Ref: 19038
24th July, 2020

RE: RM20.164 Kingston Township Wastewater – Discharge Treated Effluent into Land AEE: Aquatic Ecological and Surface Water Technical Review

Figure 2: Location of updated proposed land treatment areas (LTAs) (orange), now titled Land Treatment Command Area within the Final AEE (map sourced from LEI, May 2020).

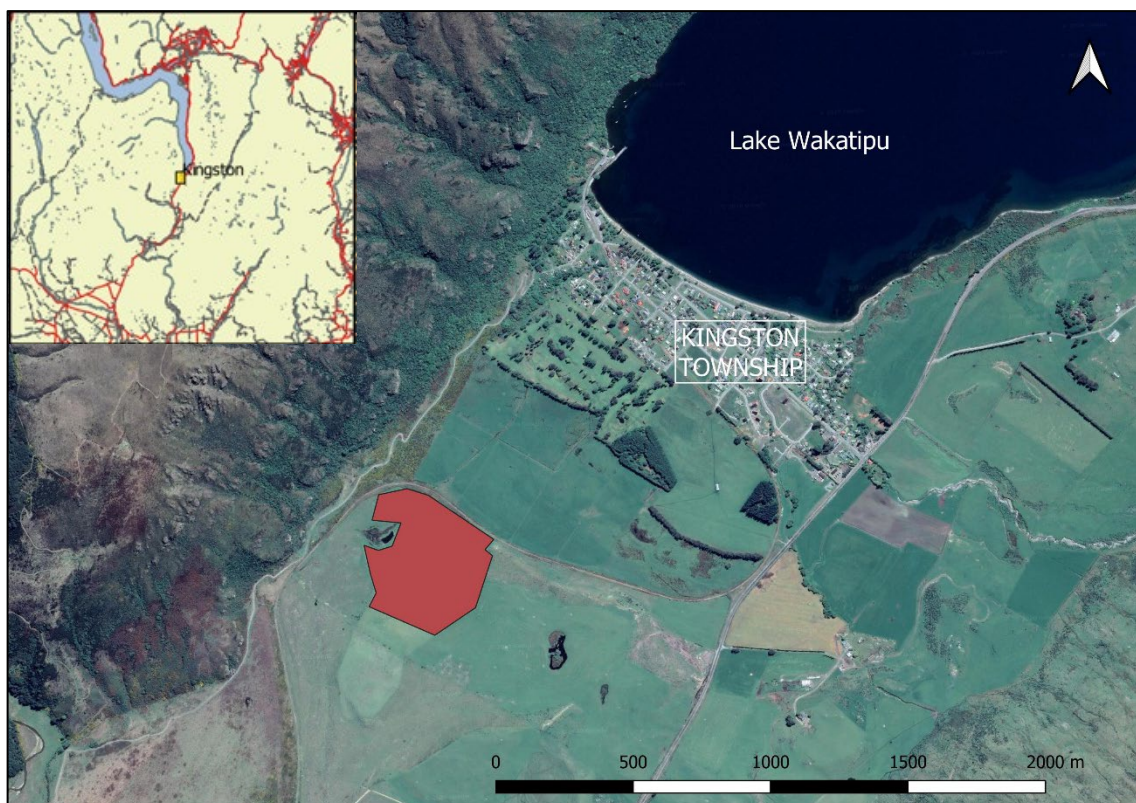
LTA 1 covers an area of ~7.5 ha to the east of LTA 2 and looks to also include a section of pond within its' proposed boundary (Figures 2 & 3). It is noted that no hydraulic conductivity tests were completed within the proposed LTA 1 (see Figures 2.7 & 2.8; LEI, May 2020) and no aquatic values are provided for this pond.

While much of the proposed LTA is delineated on suitable land upon the terrace, there are several areas of steep gullies, and the ephemeral pond and the actual pond that are within the proposed LTA area. The LTA should be delineated to avoid the ponds and areas of steep slopes to reduce the potential for throughflow and to ensure that the calculated areas are reasonable.

1. The pond extent is excluded from LTA 1 and a 10 m buffer of native riparian vegetation should occur around the pond. No irrigation within this 10 m should occur (see Appendix A for recommended species list).
